30/05/2023

Client:  
Ben Danks  
Serenescapes Landscape Designs Pty Ltd  
Level 3, Suite 54, 14 Narabang Way, Belrose, NSW 2085

Pre-Development Consultation Review  
225 Hudson Parade Clareville, NSW 2107.

An excerpt of the site survey (Vince Morgan Surveyors 29/08/2022) with Tree 1 located, TPZ (blue) and SRZ (orange) is shown below.

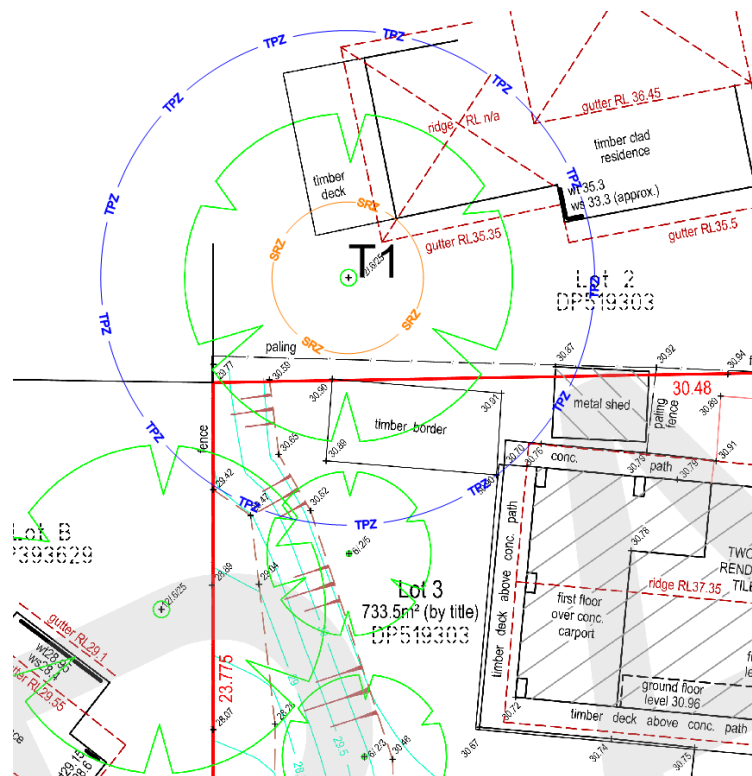
Approximately 20% of T1's TPZ extends into the subject site. Within the TPZ is existing Astro Turf laid on a concrete slab. Proposed works at or above existing grade within the location of the existing concrete slab is not likely to result in any long-lasting detrimental impacts. If proposed structures are to occupy >10% of the TPZ it is recommended that tree sensitive construction (at or above existing grade on isolated piers) is used.
